## Proposal for additions to ECE/TRANS/WP.29/GRE/2013/50

The text reproduced below proposes additions to the GTB proposal in GRE/2013/50 to improve the text following a further exchange between the experts of GTB and OICA. Additional explanations are included as mentioned in the last paragraph of the justification of GRE/2013/50.

**"Part 8 Examples to enable a decision regarding the combinations of two or more distinct parts that shall be considered to meet the definition of "single lamp" in paragraph 5.7.2.1."**

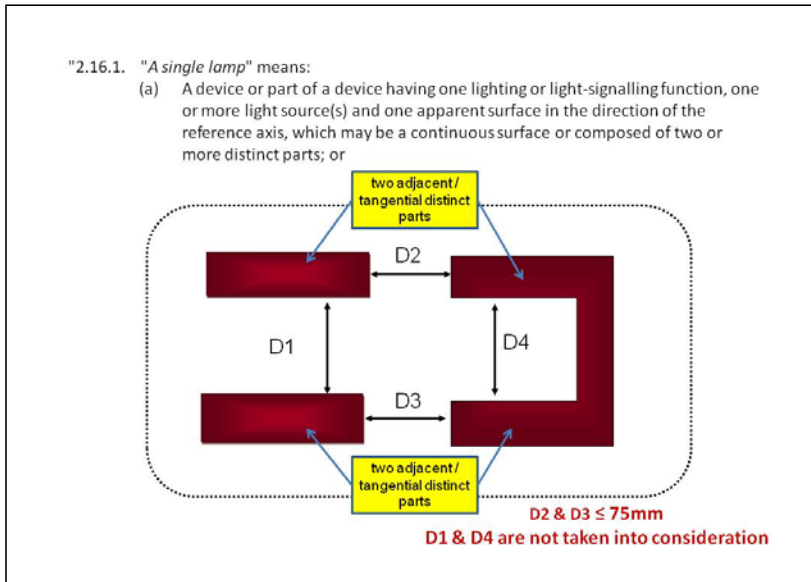
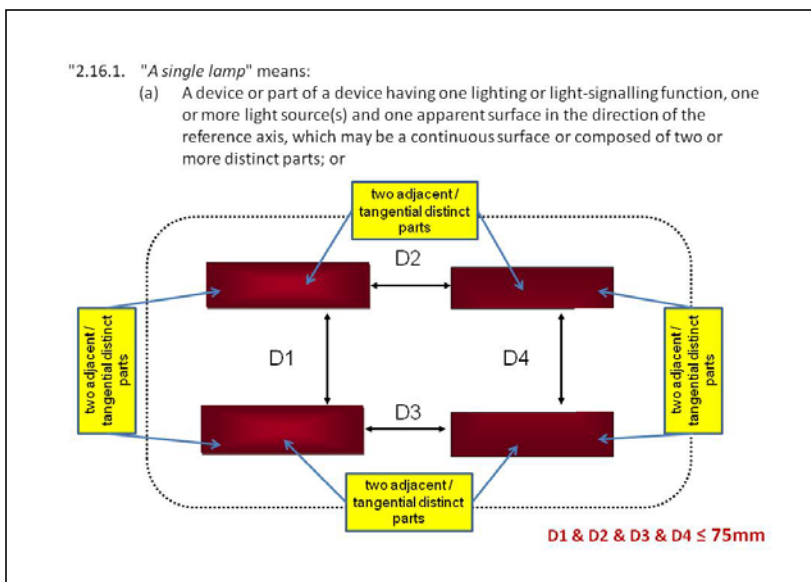
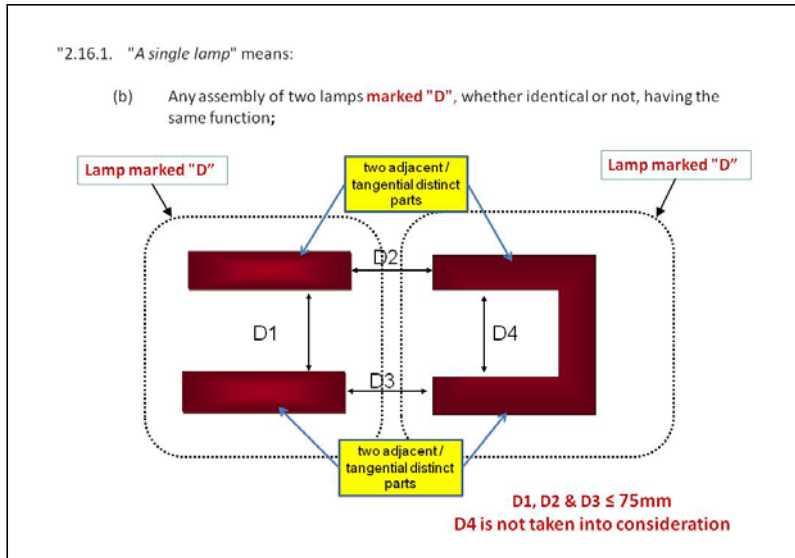
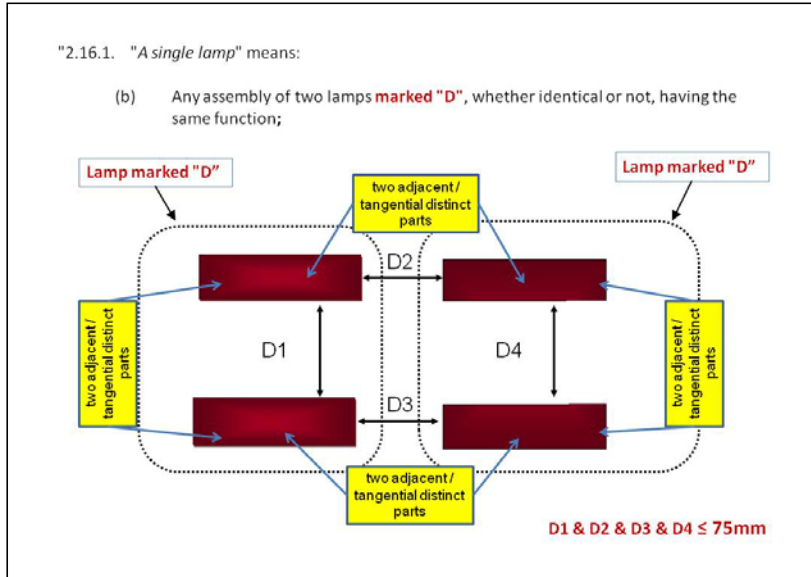
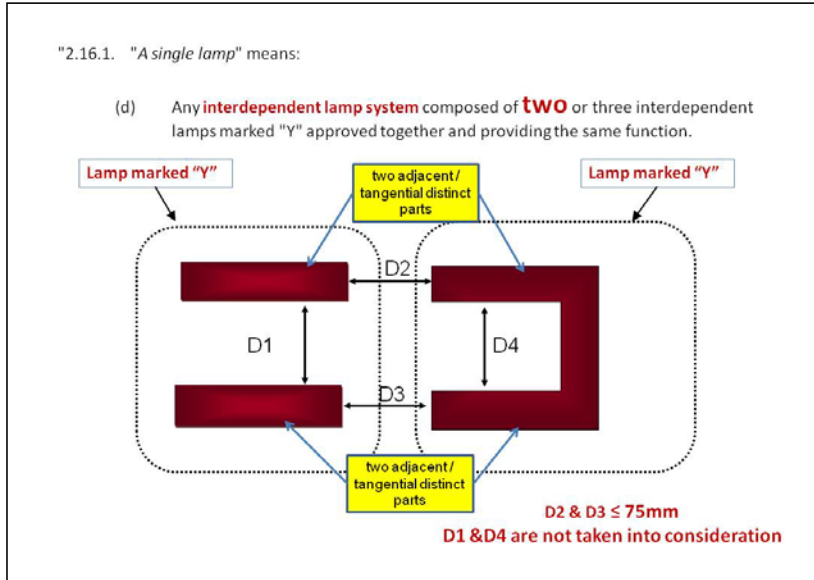
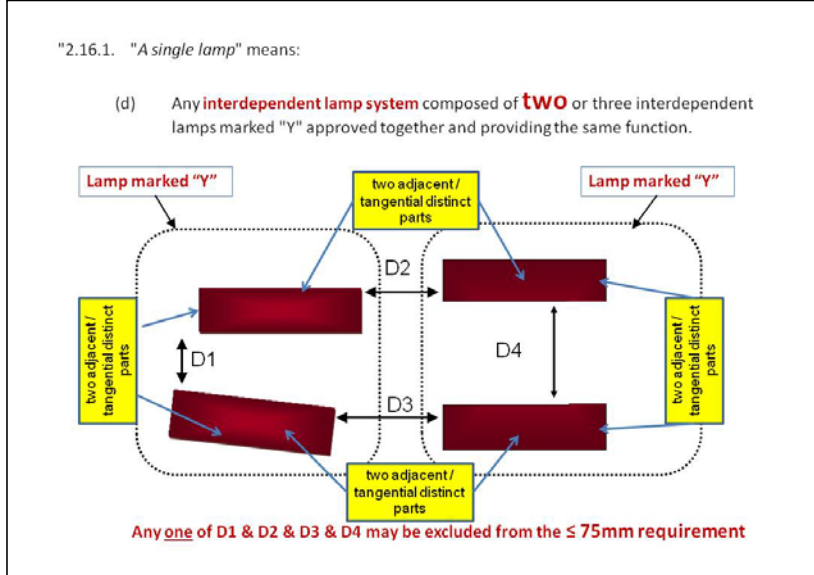
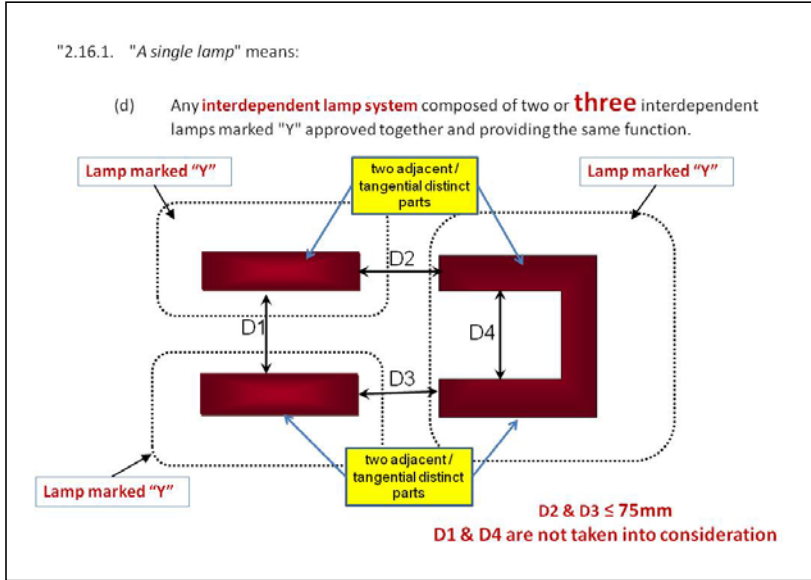
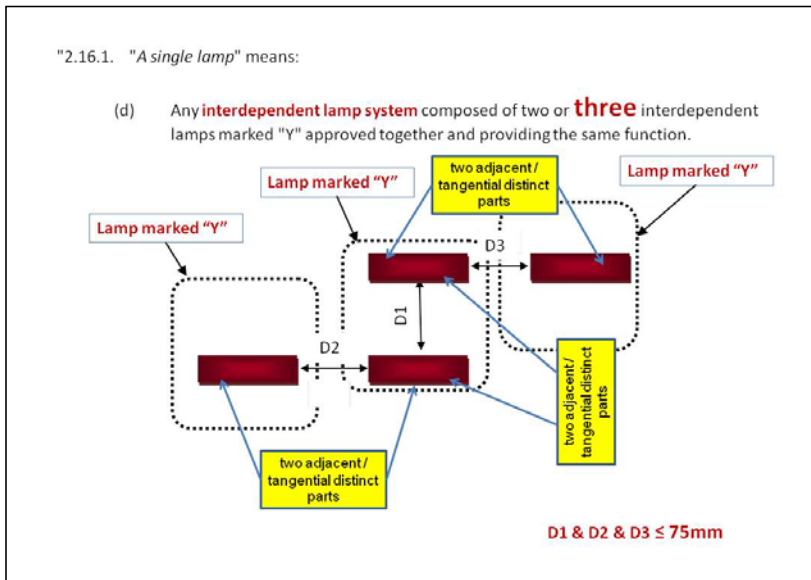
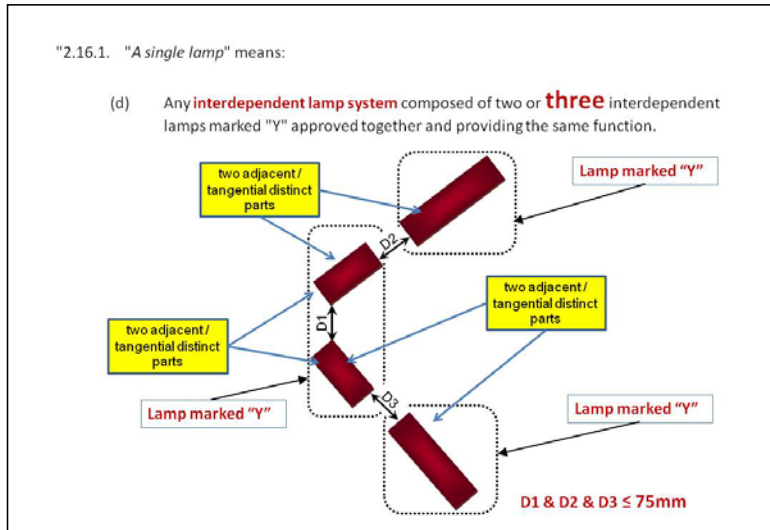
(b) **the minimum distance between the facing edges of each combination of two adjacent/tangential distinct parts shall not exceed 75 mm when measured perpendicularly to the reference axis. (See the diagrams in Annex 3, Part 8)**

Originally the diagrams introduced here were intended to be submitted in an informal document to provide some detailed supporting explanation. However, during drafting of the information it became apparent that the diagrams should be integrated into annex 3 to the regulation.

These examples are intended to provide some guidance with regard to the application of the definition of “single lamp”. The installation and juxtaposition of these single lamps shall comply with the specific provisions in this regulations concerning positioning, geometric visibility, photometric performance etc.”

**“Part 9 Example of an installation according to the provisions of paragraph 2.16.1.”**

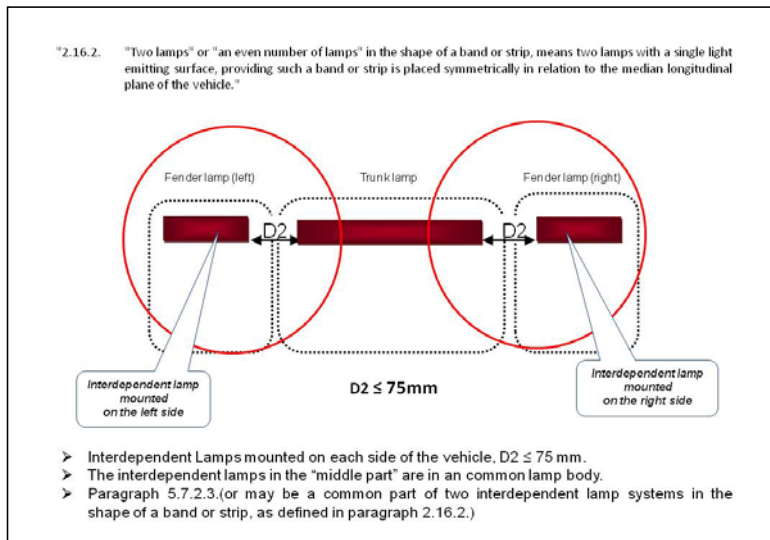
Originally this diagram introduced here was intended to be submitted in an informal document to provide some detailed supporting explanation. However, during drafting of the information it became apparent that the diagram should be integrated into annex 3 to the regulation.

This example is intended to provide guidance with regard to the application of the definition of “single lamp” in the context of paragraph 2.16.1 of this regulation. The installation and juxtaposition of these “single lamps” shall comply with the specific provisions in this regulations concerning positioning, geometric visibility, photometric performance etc.”
